APPEAL PACKET FORM
(Chapter 2.88.050 of Napa County Code)

Re: Appeal of Approval of Agricultural Erosion Control Plan No. P11-00205-ECPA and certification of Final Environmental Impact Report under the California Environmental Quality Act for the Walt Ranch Vineyard Conversion Project.

Subject: Landslide Hazard Assessment
Walt Ranch Erosion Control Plan (P11-00205-ECPA)
Walt Ranch Project, Napa, CA

FIGURE 2: Hydrologic model configuration for proposed conditions (no drainage and with drainage improvements) drainage outfall from Vineyard Block 21B.

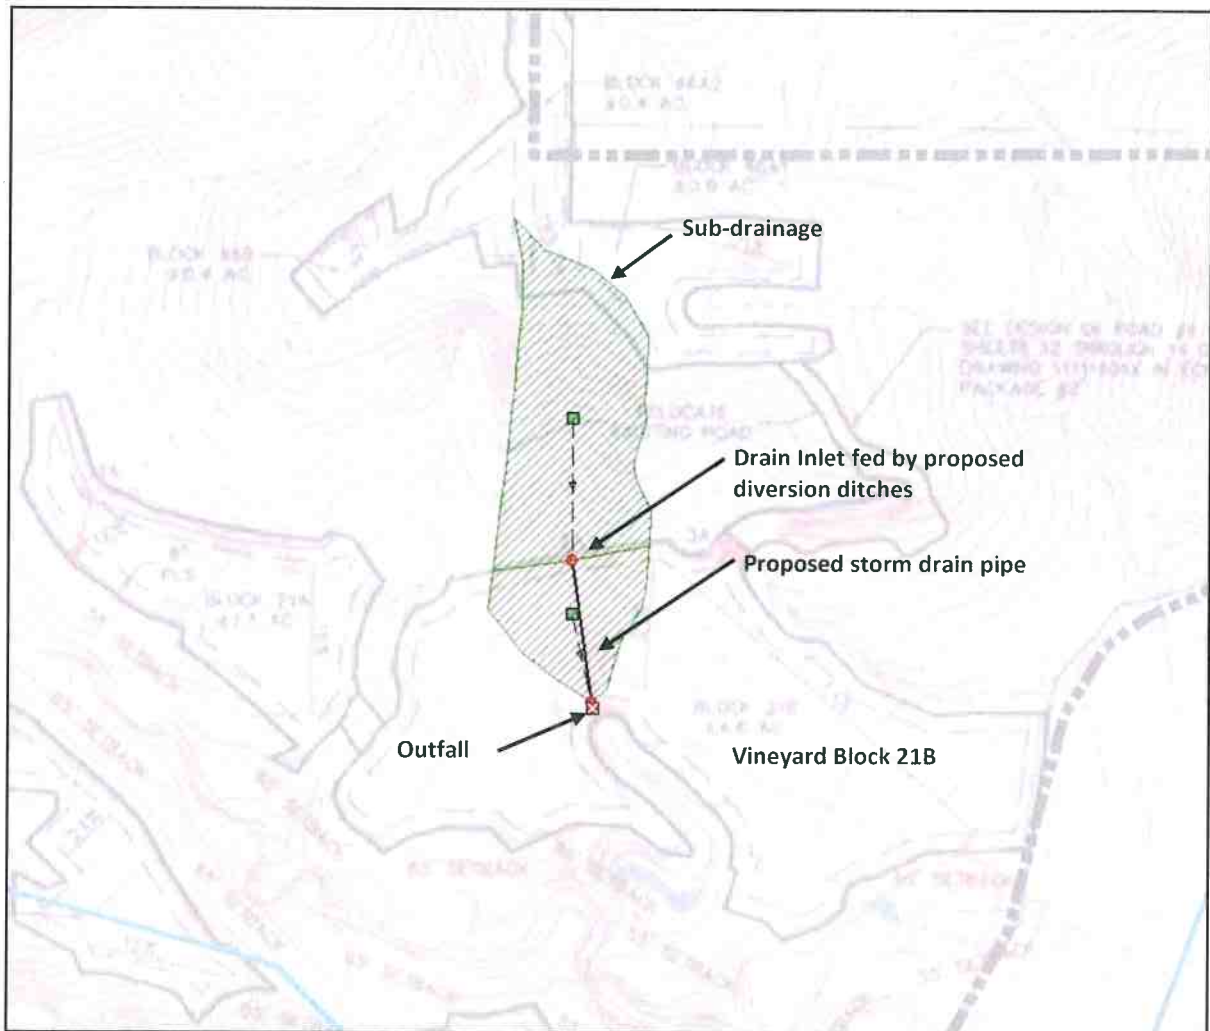
To better understand and quantify the different effect runoff curve number and drainage elements have on storm runoff, we completed a hydrologic modeling analysis on a proposed drainage outfall in Vineyard Block 21B. We chose this site because the EIR concludes that the drainage area to this outfall does not change between pre- and post-project conditions [cite to page number] and the vineyard block includes drainage elements including internal diversion ditches that feed into a surface drainage pipeline [cite to page number]. Figure 1 presents the 2.17-acre drainage area contributing to the outfall. Approximately two-thirds of the drainage area lies north of the proposed vineyard block while the lower third of the drainage area lies within the vineyard.

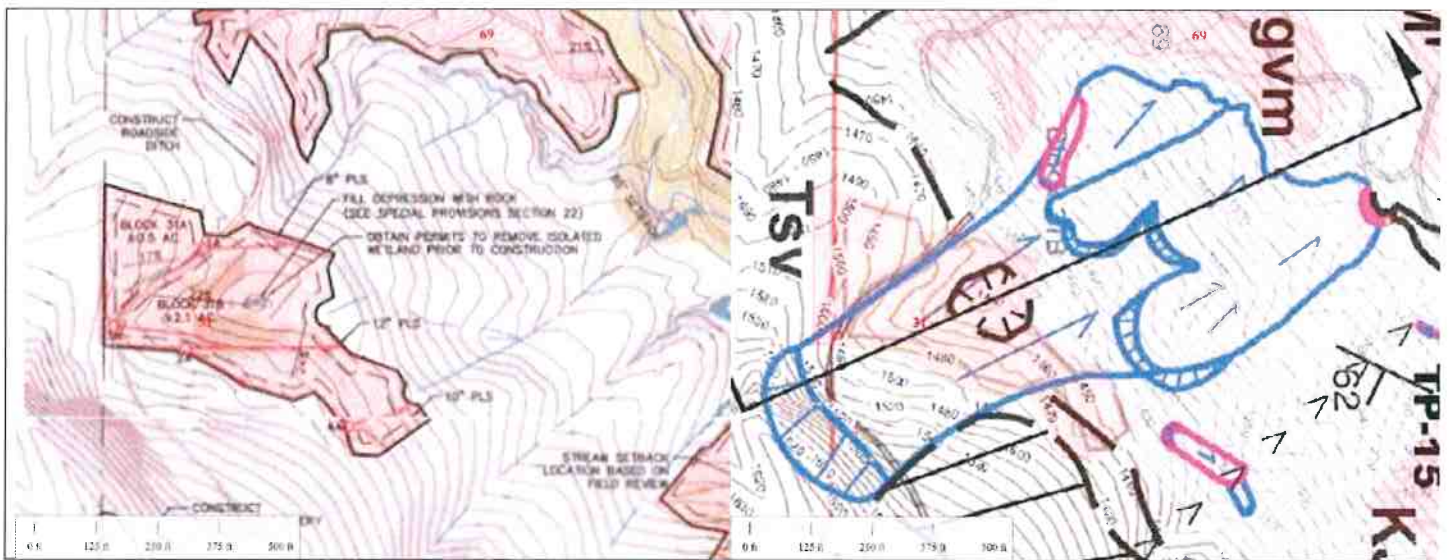
Contrary to the statements by Gilpin, we have identified a number of vineyard blocks that discharge runoff from vineyard blocks directly onto mapped landslides. We identified these vineyards by georeferencing and overlaying project erosion control plans and the site geologic map. We evaluated a subset of the 69 vineyard blocks, focusing only on the 41 blocks where post-project storm runoff rates exceed pre-project rates as estimated by RiverSmith (2013). Of these blocks, we found that drainage from blocks 31A, 40B, 50, 52, 54, 57 and 61 will be directed directly onto mapped landslides. A comparison of erosion control plans⁴ and landslide conditions at each of these vineyard blocks are presented in Figures 5 through 10. In order to mitigate for the increased flow rates from these blocks (i.e., reduce them to pre-project levels), the following mitigation measures are proposed: installation of small detention structure or gravel berm on downslope edge of the turnaround avenue at Blocks 31A and 40B; installation of localized detention structure of appropriate size at Blocks 50 and 52; and installation of a gravel berm on the downslope edge of the turnaround avenue at Blocks 54, 57, and 61. All of these proposed berm and detention structures will be located on mapped landslides (Figures 5-10). This will result in water being ponded and possible dispersed more widely on landslide deposits if a structure is overtopped. These mitigations will promote and concentrate infiltration into landslide deposits to a greater degree than would occur under pre-project conditions. Thus, proposed project mitigations are increasing the potential to reactive landslides in these seven specific areas. Although the remaining 34 berm and/or detention sites are not located on active or dormant landslides, they occur in geology and soils prone to sliding and also introduce an
